PNP 2014-066

SUBJECT: Supplemental Response to NRC Request for Additional Information -
Palisades Nuclear Plant 10 CFR 50 Appendix G Equivalent Margin
Analysis – MF 2962

Palisades Nuclear Plant
Docket No. 50-255
License No. DPR-20

SUPPLEMENTAL RESPONSE TO NRC REQUEST FOR ADDITIONAL INFORMATION – PALISADES NUCLEAR PLANT 10 CFR 50 APPENDIX G EQUIVALENT MARGIN ANALYSIS - MF 2962

WCAP-17651-NP New Figure 5-14: Applied J-Integral versus Crack Extension for Axial Flaw – 1/4t, Level A and B

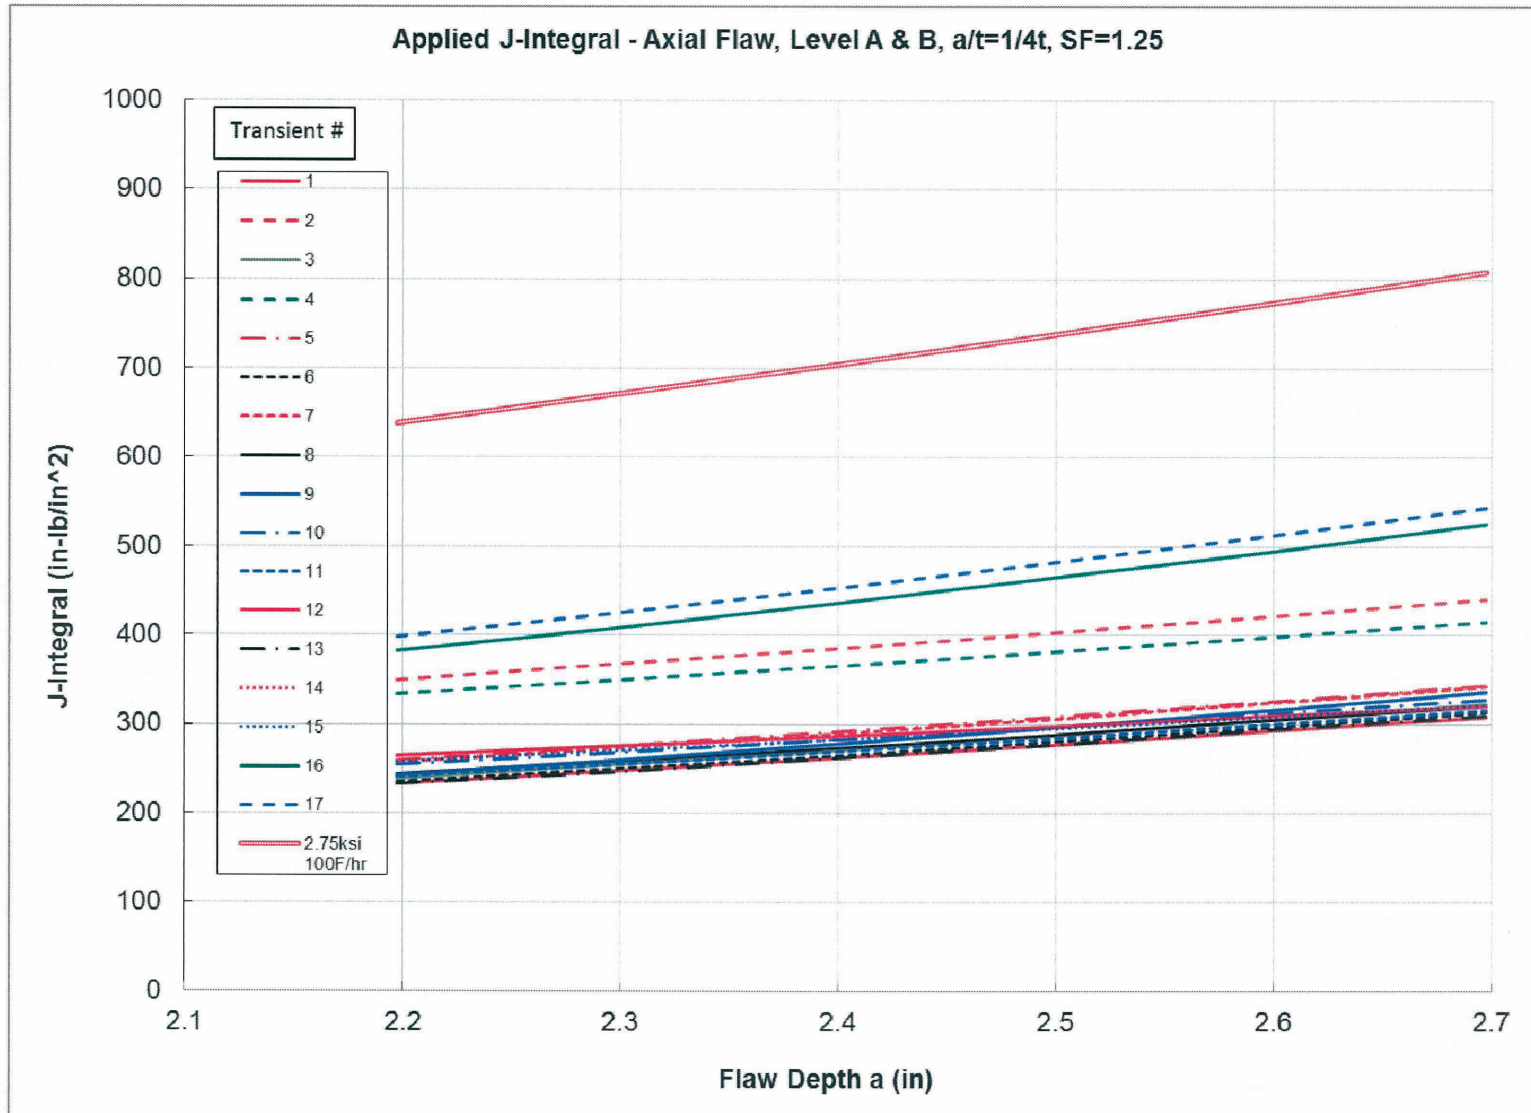
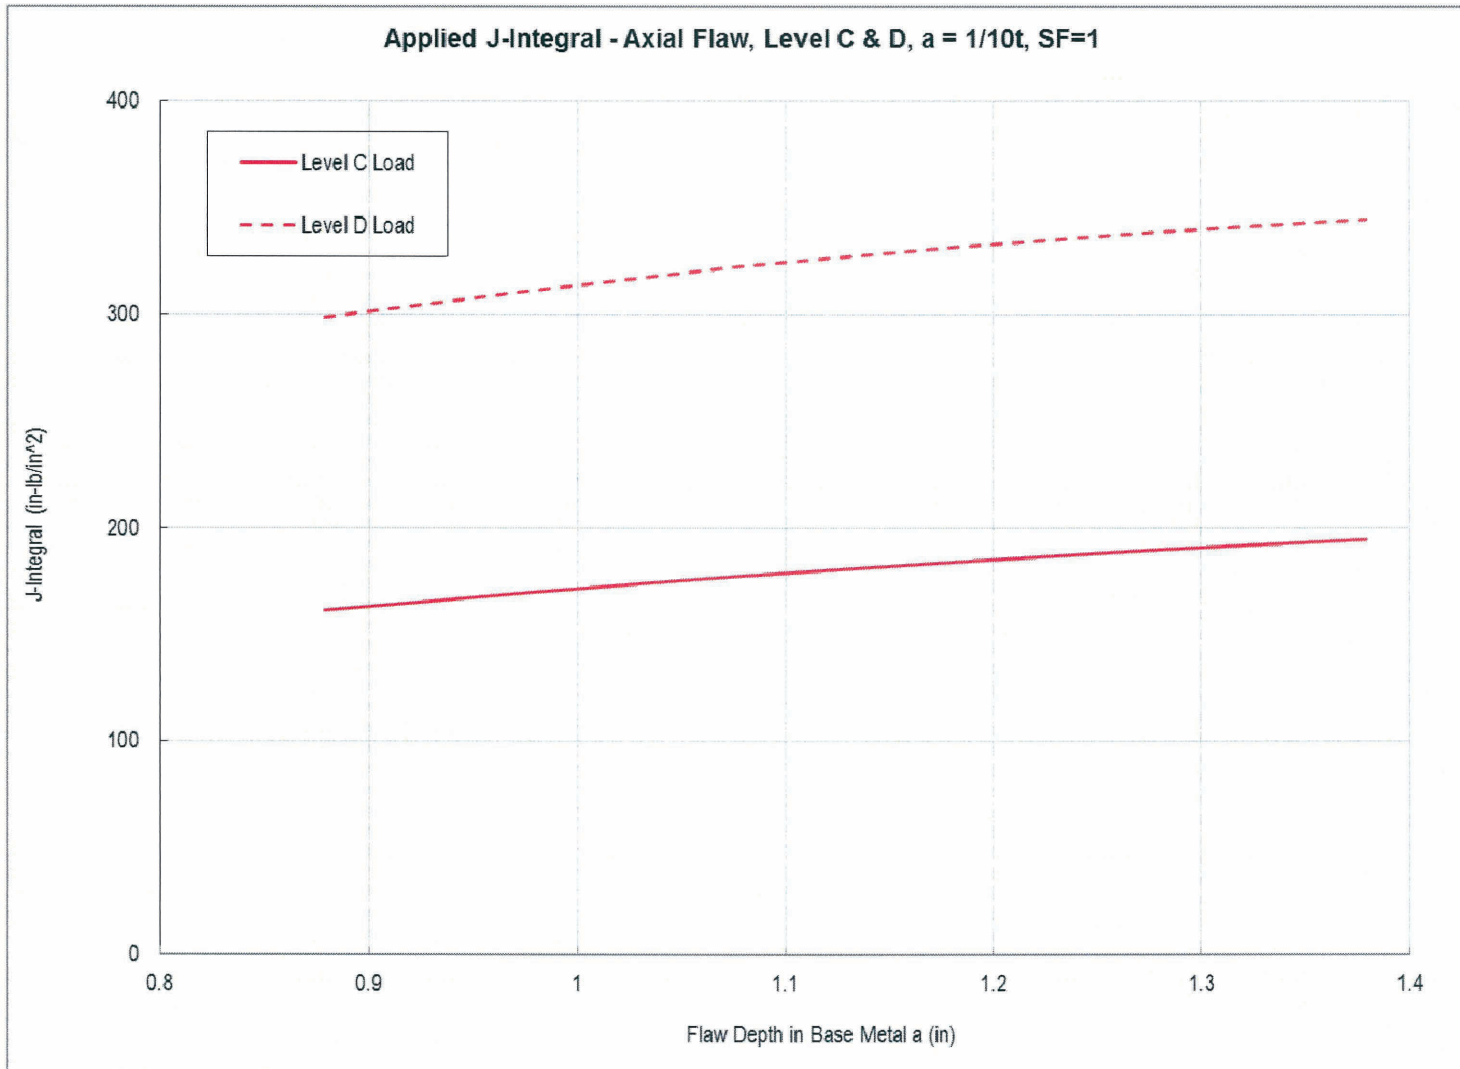
- 2. Section 5.1 states, "Only circumferential base metal flaws are considered in this analysis, because only the "weak" orientation USE is projected to drop below 50 ft-lbs as described below." Please demonstrate that assuming a circumferential flaw in the base metal with the weak Charpy V-Notch (CVN) value in the EMA is more limiting than assuming an axial flaw in the base metal with the strong CVN value. Please note that the significantly greater applied J integral associated with the axial flaw may challenge the fundamental assumption in the EMA submittal.*

New Table 5-8 details the axial flaw safety factors for all transients, Levels A, B, C and D, with consideration of the Regulatory Guide 1.161 J-R model and limiting EOLE USE equal to 73 ft-lbs per WCAP-17651-NP. New Table 5-9 details the axial flaw safety factors for all transients, Levels A, B, C and D, with consideration of the V-50 plate data adjusted to the L-T orientation. New Figures 5-14 and 5-15 detail the applied J-Integral versus crack extension for axial flaws at 1/4t for Level A and B transients and applied J-Integral versus crack extension for axial flaws at 1/10t for Levels C and D transients, respectively. New Figure 5-16 details the axial flaw J-Integral versus crack extension at 1/4t for Level A and B transients for base metal with Regulatory Guide 1.161 model J-R curves and V-50 plate data included. New Figure 5-17 details the axial flaw J-Integral versus crack extension at 1/4t, pressure = 2.75 ksi, and a 100°F/hr cooldown transient for base metal with Regulatory Guide 1.161 model J-R curves and V-50 plate data included. Lastly, new Figure 5-18 details the axial flaw J-Integral versus crack extension at 1/10t for Levels C and D transients, for base metal with Regulatory Guide 1.161 model J-R curves and V-50 plate data included.

The minimum safety factor with consideration of the Regulatory Guide 1.161 J-R model, L-T orientation USE values and the PNP-specific axial flaw J-Applied values is 1.7 while the minimum safety factor with relative to the V-50 plate data and the PNP-specific axial flaw J-applied values is 1.4 at 0.1-inch crack extension. All these cases have their structural factors above the minimum requirement of 1.15 per Regulatory Guide 1.161 and are deemed acceptable. The flaw extension figures demonstrate that the NRC Regulatory Guide 100°F/hr cooldown transient with the accumulation pressure levels governs the Level A and B transients, which is the limiting case. All cases, where the Regulatory Guide 1.161 J-R material correlation is considered with axial flaw J-Applied pressure loadings, are acceptable with the applied J-integral values at 0.1-inch crack extensions below the material J-resistance ($J_{0.1}$) as required by the ASME Code Appendix K. In some instances with consideration of the V-50 plate data adjusted to the L-T orientation, the J-Material curves, adjusted to transient temperature, are either slightly below or just over the J-applied values, specifically for the Regulatory Guide 1.161 100°F/hour cooldown transient. However, as discussed above, the V-50 data is a lower bound high-sulfur data set, that is not fully representative of the PNP actual plate materials, and this result can be considered acceptable with consideration of the associated Regulatory Guide 1.161 model, and the structural factor (SF) calculations shown in Tables 5-8 and 5-9. Finally, as discussed above, the Regulatory Guide 1.161 100°F/hour cooldown transient is more limiting than the PNP-specific transients, as shown in the comparison of J-Applied curves in Figures 5-16 and 5-17. Note that the Regulatory Guide 1.161 100°F/hour cooldown transient with pressure of 2.75 ksi is more conservative than PNP cooldown transient with pressure of 2.13 ksi.
